No. 2176
ATA Code 27-50, 32-30

SUBJECT: FLIGHT CONTROLS - MODIFICATION OF FLAP AND LANDING GEAR SELECTOR SWITCH KNOBS

Service Bulletin No. 2176

**Flap Selector Switch Lever Modification
Figure 1**

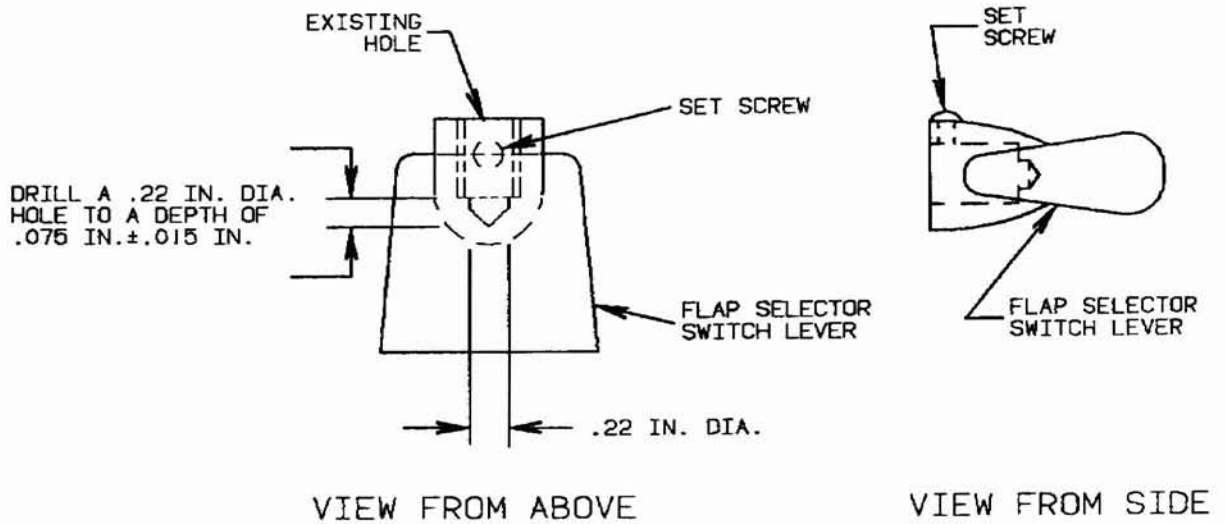
FLAP SELECTOR SWITCH LEVER MODIFICATION

1. Remove the flap selector lever by loosening the set screw and unscrewing the lever from the selector switch.
2. Drill a .22 inch diameter hole down through the center of the existing mounting hole to a depth of .075 inch \pm .015 inch, as shown in Figure 1.
3. Reinstall the lever on the switch.
4. Tighten the set screw.

**Landing Gear Selector Switch Lever Modification
Figure 2**

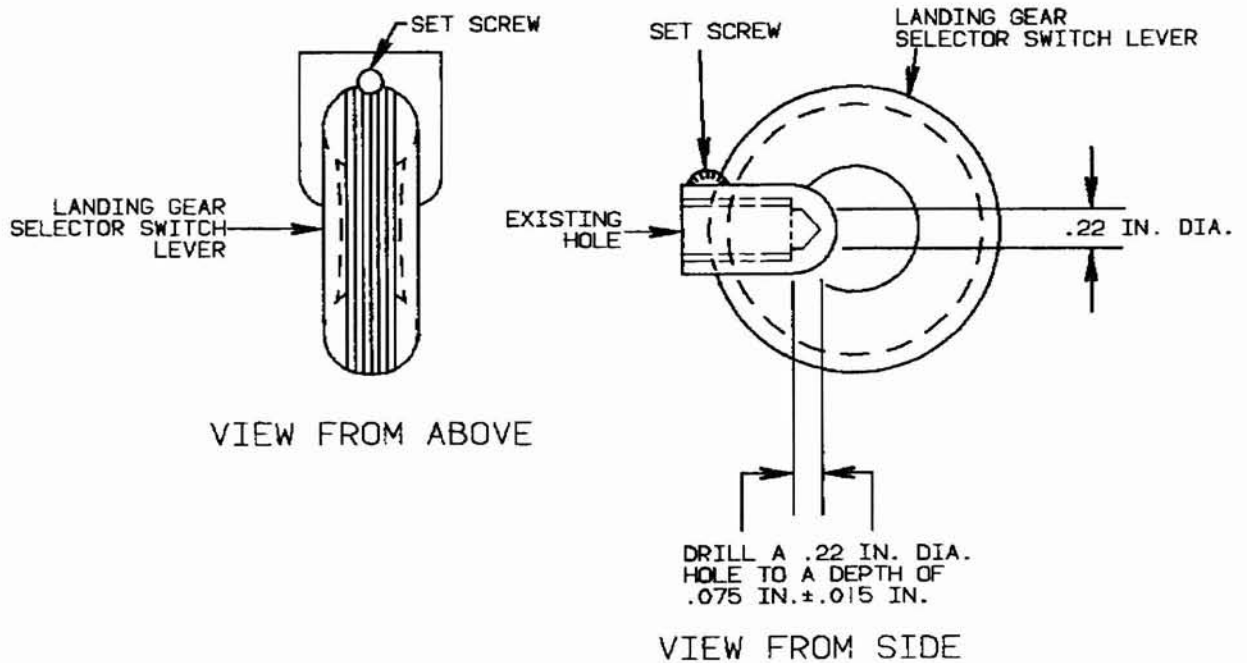
LANDING GEAR SELECTOR SWITCH LEVER MODIFICATION

1. Remove the landing gear selector lever by loosening the set screw and unscrewing the lever from the selector switch.
2. Drill a .22 inch diameter hole down through the center of the existing mounting hole to a depth of .075 inch \pm .015 inch, as shown in Figure 2.
3. Reinstall the lever on the switch.
4. Tighten the set screw.
